Responses to CEC Data Requests Set Two: Nos. A124 through A180

Amended Application for Certification
for
HYDROGEN ENERGY CALIFORNIA
(08-AFC-8A)
Kern County, California

**RESPONSES TO DATA REQUESTS A124 THROUGH A180
FROM CALIFORNIA ENERGY COMMISSION (CEC)**

FIGURE A149-1 - SHEET 5

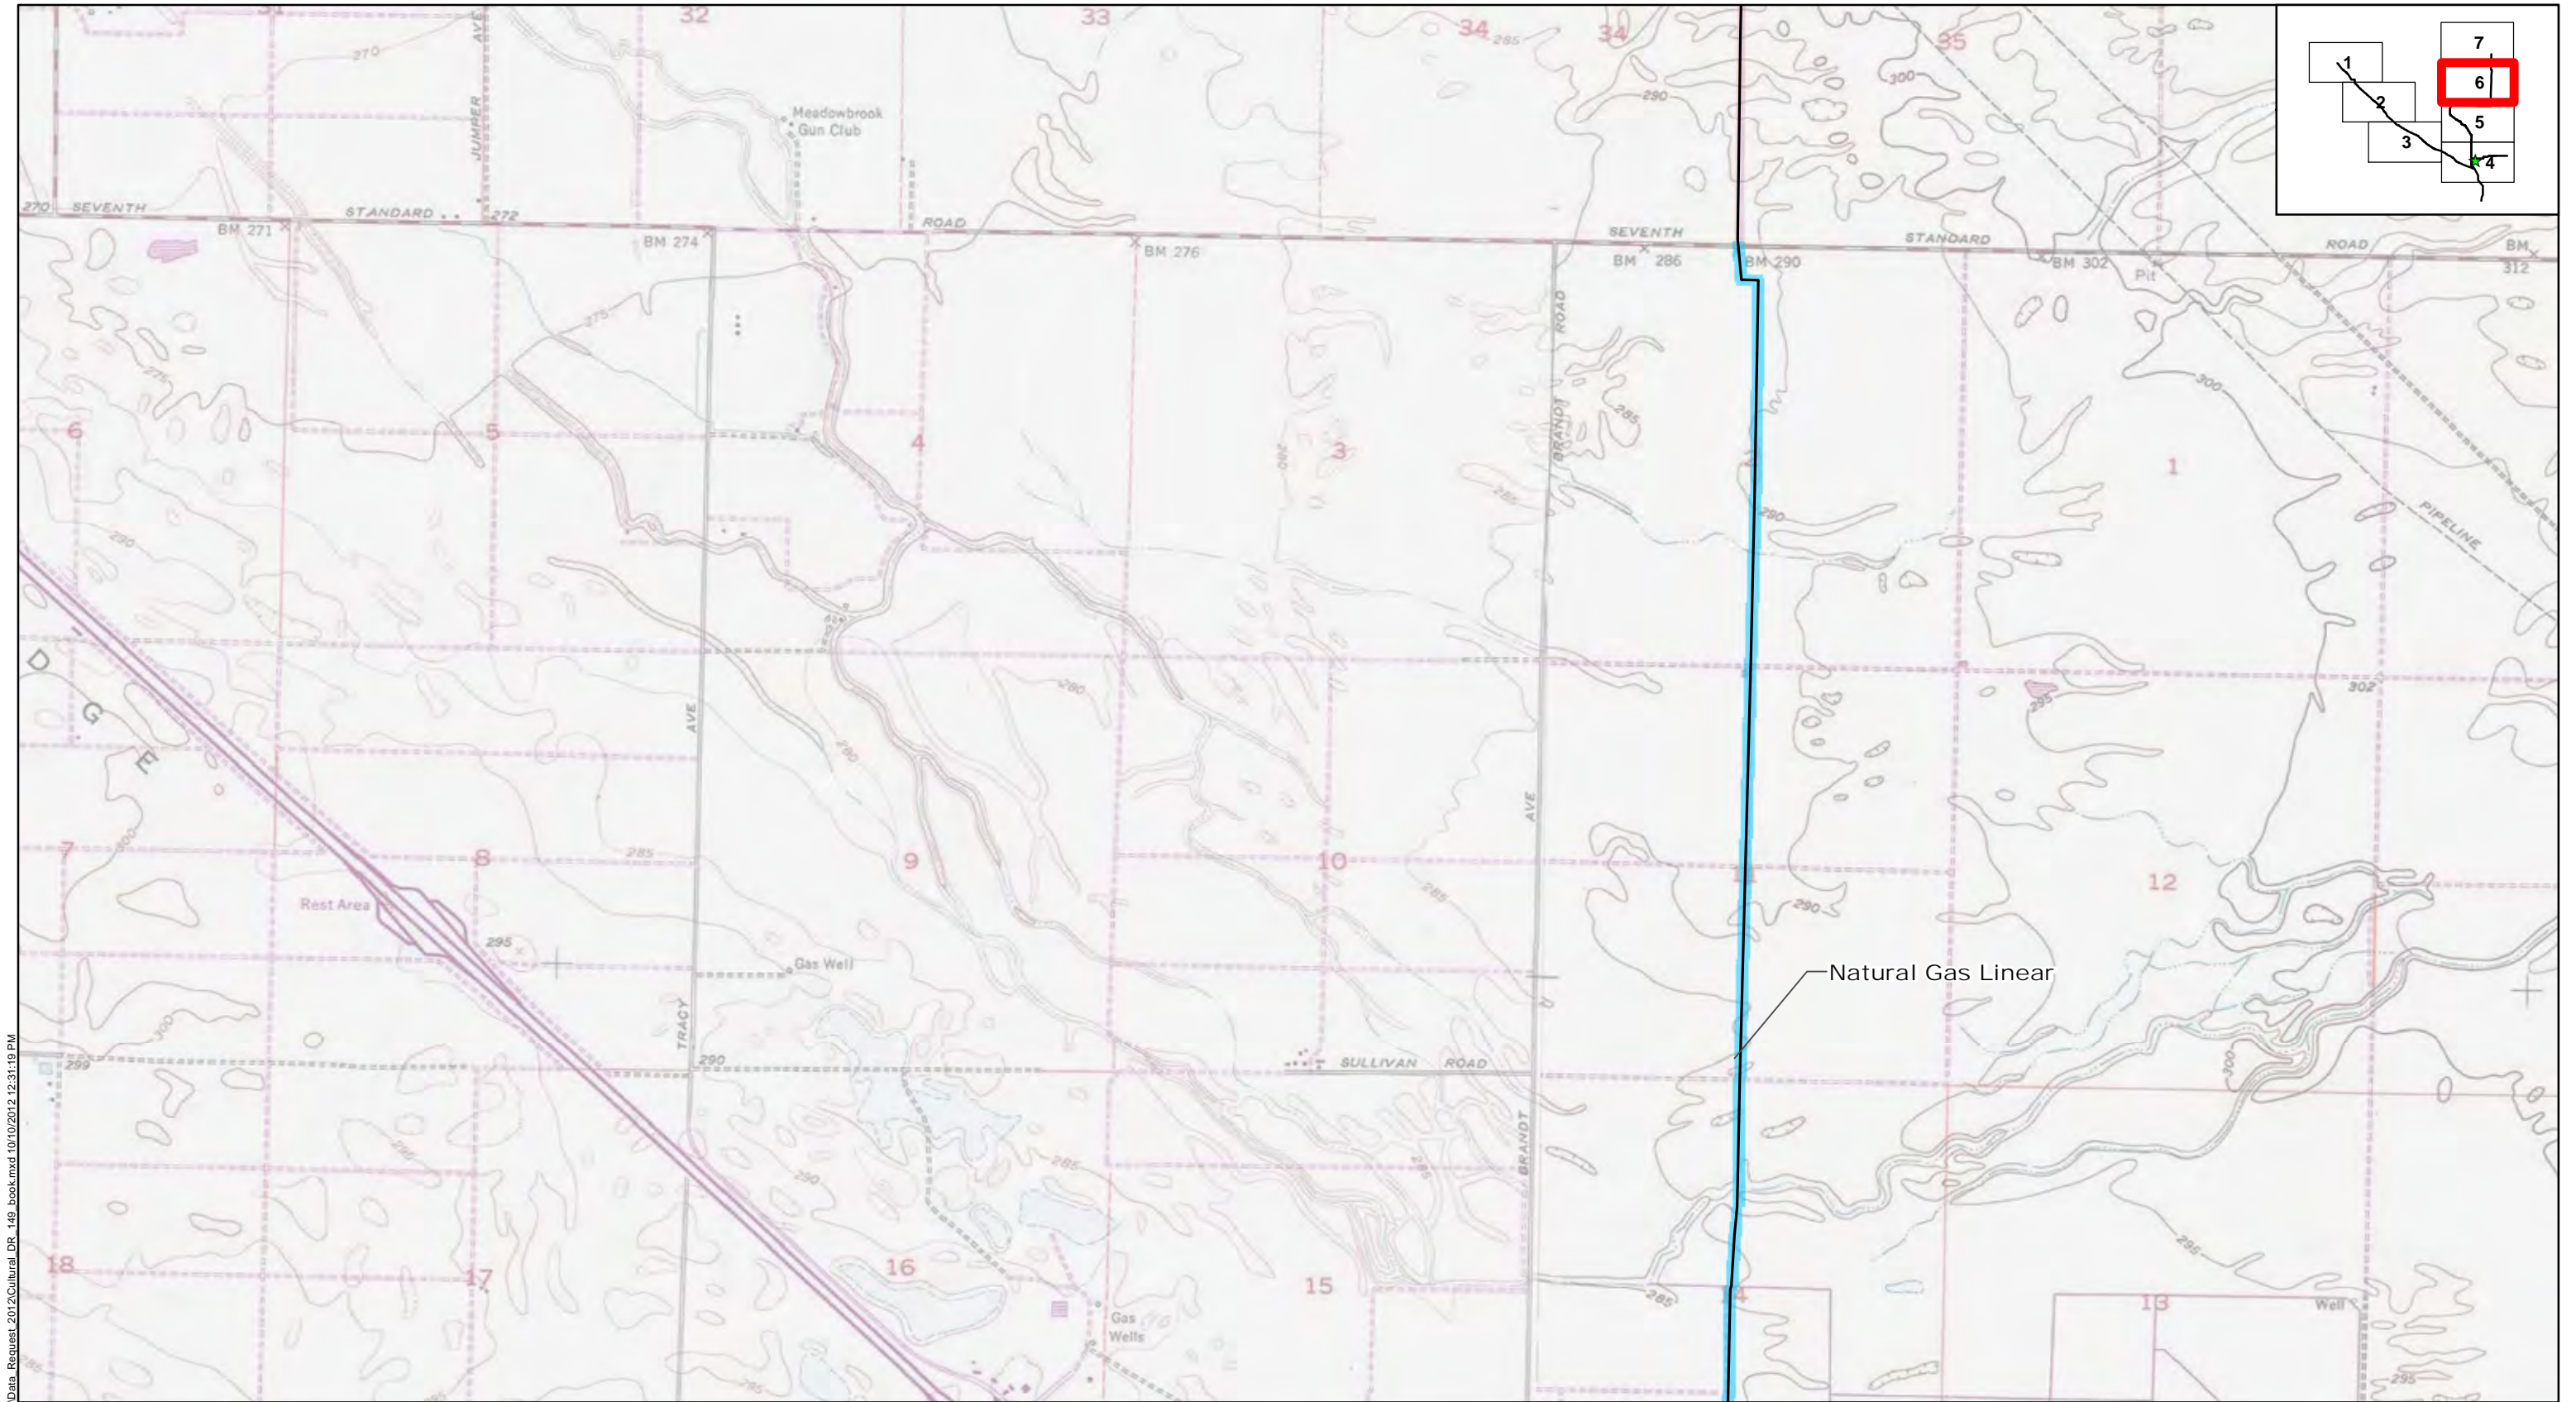
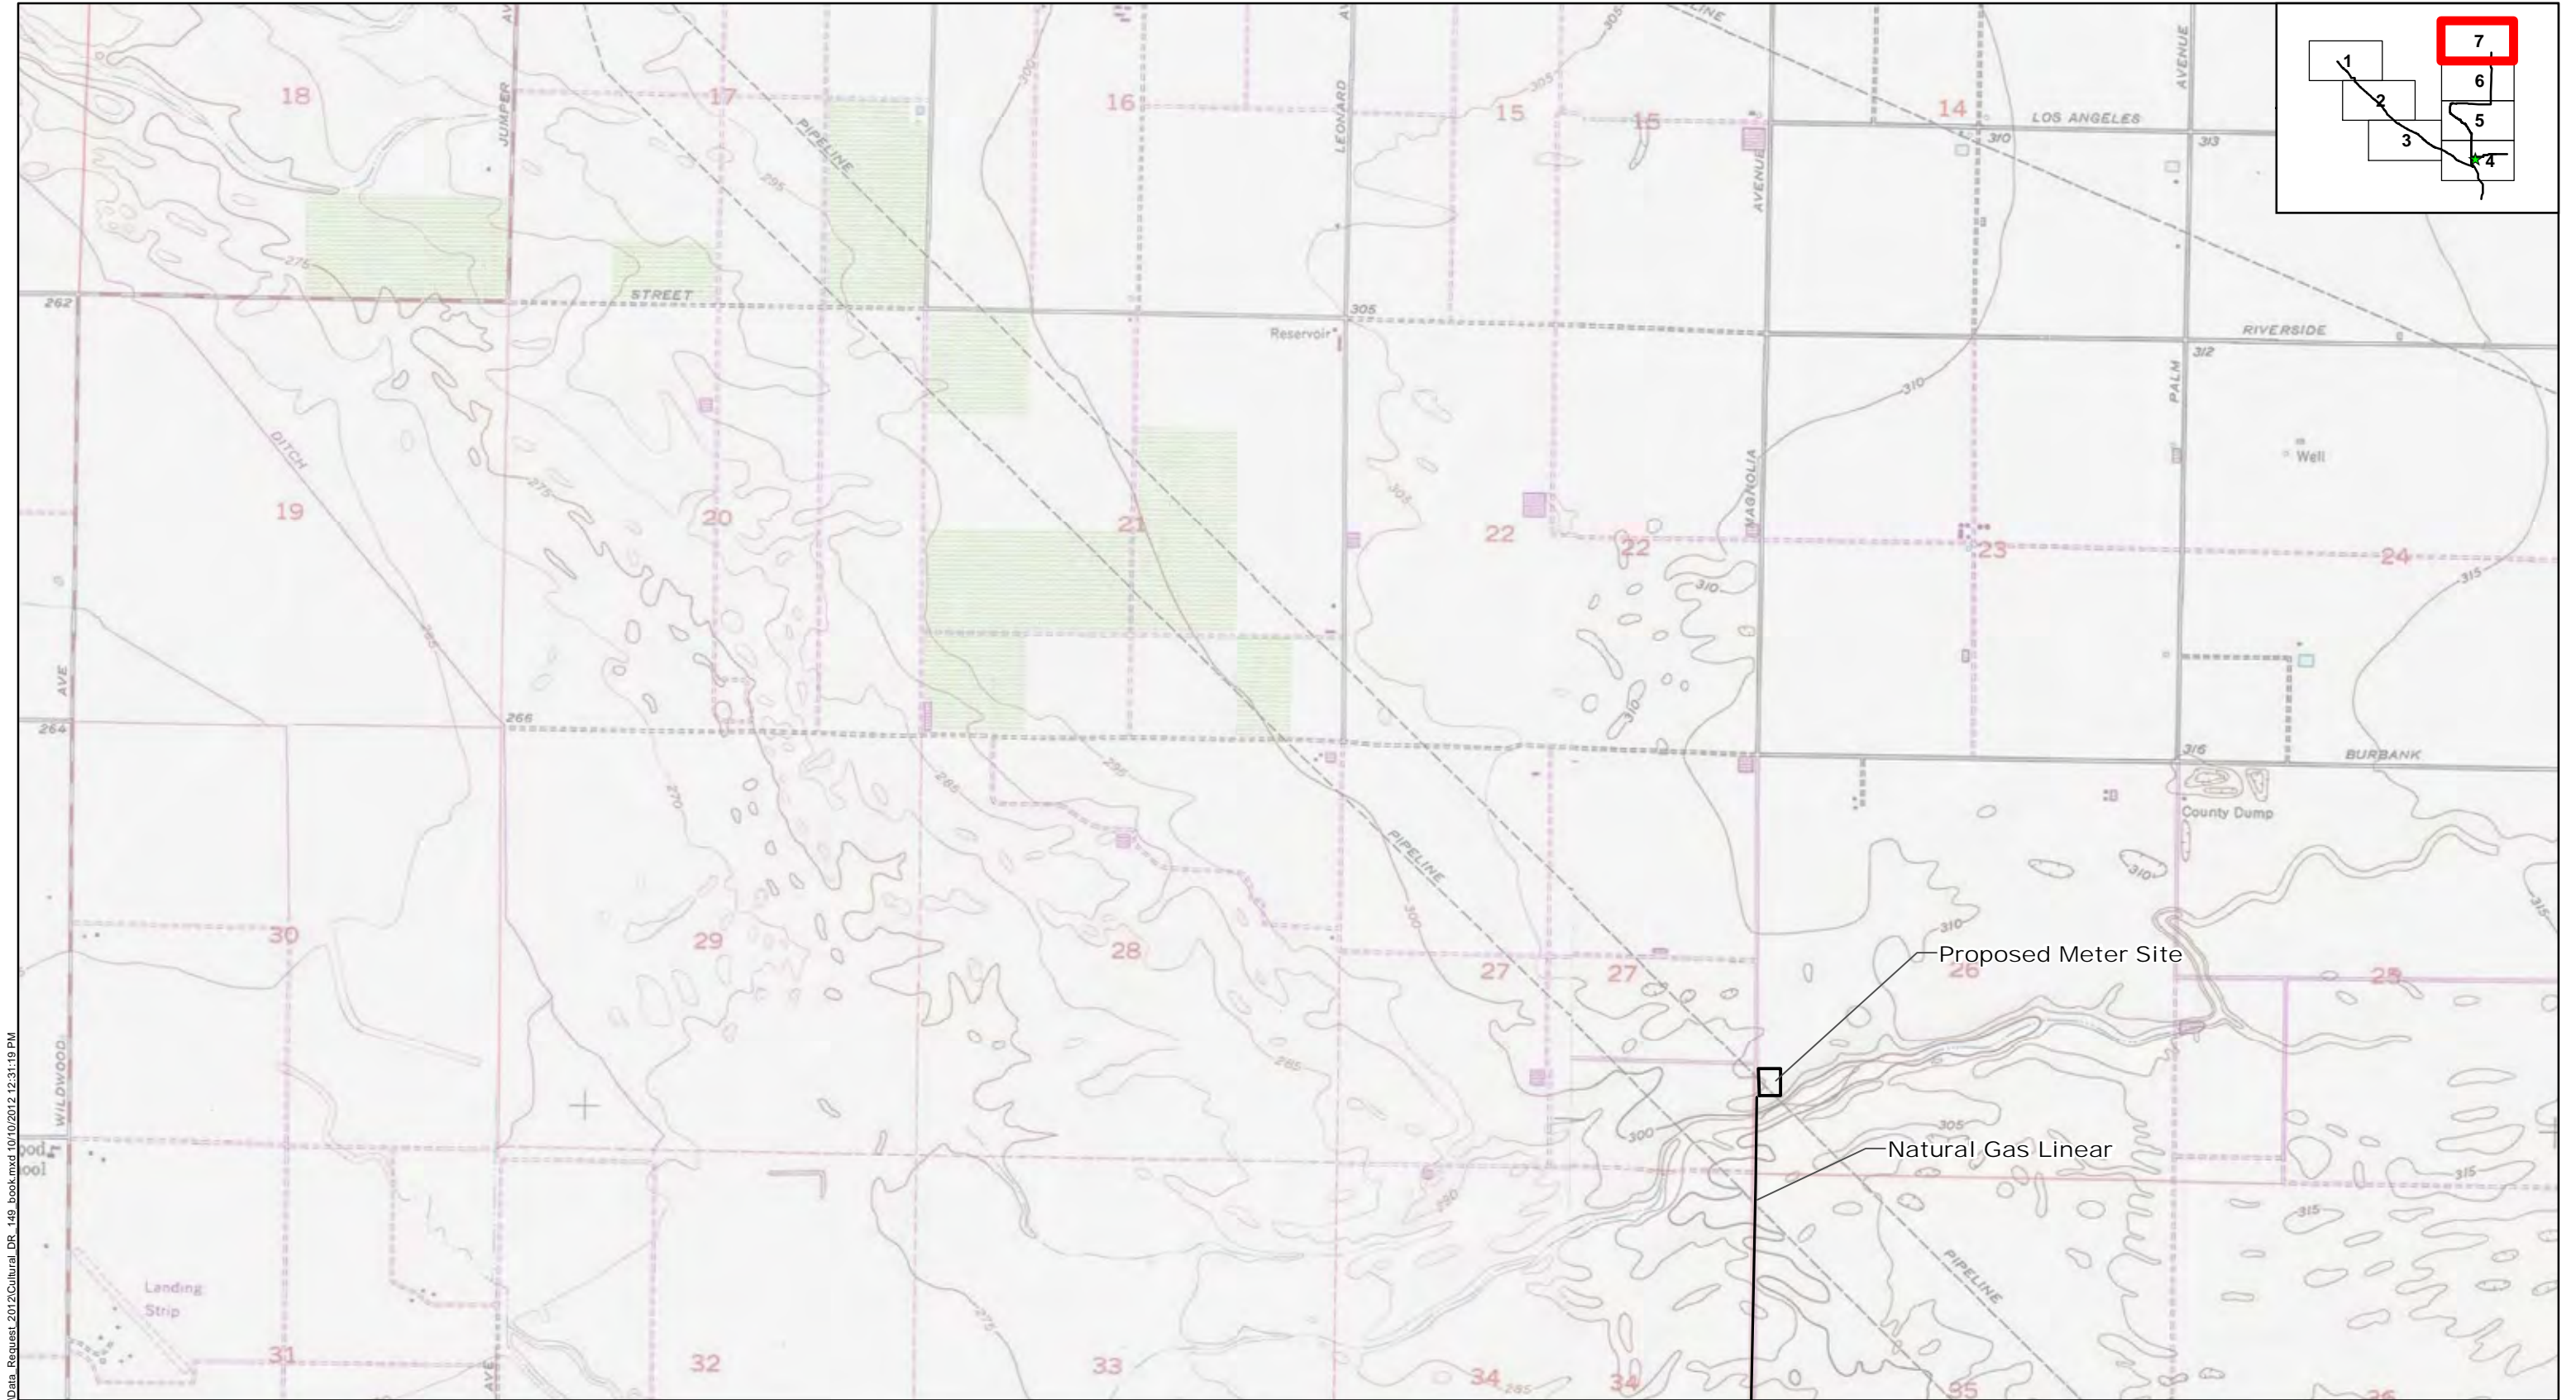
A149. Please provide survey coverage figures on a 7.5-minute topographic quadrangle base (set at 7.5-minute scale). The figures must include all project elements and boundaries of the areas actually surveyed.

A map set depicting all survey coverage on 7.5-minute topographic quadrangles has been prepared, and is presented on Figure A149-1.
